Work Order ID 132279

Item Name: Aft Crosstube - High 407

Reference: REWORK PER ECN 15-557

DRAWN	RF		
CHECKED	9P		
MFG. APPR.	9P		
APPROVED	9P		
DE APPR.	9P		
DATE	15.03.20		
DART AEROSPACE LTD HAWKESBURY, ONTARIO, CANADA DRAWING NO. D407-667-245 TITLE CROSSTUBE ASS'Y (407 HIGH AFT) REV. G SHEET 1 OF 4 SCALE NTS COPYRIGHT © 2002 BY DART AEROSPACE LTD THIS DOCUMENT IS PRIVATE AND CONFIDENTIAL AND IS SUPPLIED ON THE EXPRESS CONDITION THAT IT IS NOT TO BE USED FOR ANY PURPOSE OR COPIED OR COMMUNICATED TO ANY OTHER PERSON WITHOUT WRITTEN PERMISSION FROM DART AEROSPACE LTD.

D407-667-245
ASSEMBLY DETAIL
(VIEW LOOKING FWD)

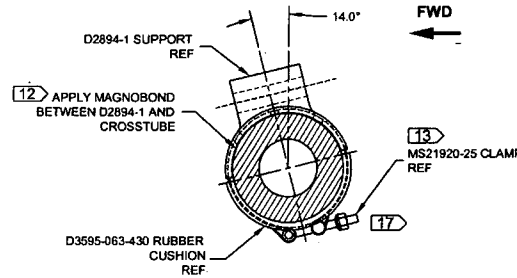
G	INCORP. DEO's D407-667-245-F1/F2 (ZN D8-1, A8-1, D5-2, B6-2, C6-2); 8.90 WAS 8.53 (ZN D5-2); TORQUE REDUCED FOR CHAFING SHIELD (ZN A8-1); FINISH REVISED TO ALLOW MANUFAC. FLEXIBILITY (ZN C8-1)	RF	15.03.20
F	REFORMAT NOTES TO NEW STANDARDS (ZN B8-1); RELOCATED FLAG #6 (ZN A8-3) PER NCR 210; REMOVED REF. & ADD TOLERANCES (ZN C6-3, C4-3 & D2-3)	RF	08.11.06
E	8.02 AND 8.53 WERE 8.40 AND 8.90 (ZN D5-2); REORGANIZED VIEWS AND REFORMATED DRAWING TO CURRENT STANDARDS. REASONS: CLAMPS MOVED 0.375 TOWARD CL TO ELIMINATE INTERFERENCE WITH AIRCRAFT MOUNTS. REFERENCE: PAR#08-21 AND ECN#1225	MB	08.07.24
D	ADD VIEW FOR OEM SKID HOLES, ROTATE ORIENTATION OF CLAMPS SECTION F-F, REMOVE -851 ABRASION STRIP, ADD MAGNABOND 6398, ADD CUSHION	PH	07.02.07
C	ADD HOLES AND NUT PLATES FOR COMPATIBILITY WITH BHT/AA SKIDTUBES	PH	05.07.26
B	ADD CHAFING SHIELD	CP	03.05.21
A	NEW ISSUE	CP	02.05.13
REV.	DESCRIPTION	BY	DATE
DESIGN	9P

1- Install chafing shield as per D407-667-245 using DT10096 to establish 8.90
dimension. Top holes should be facing up.

****Ensure chaffing is to be position "overlap" AFT****
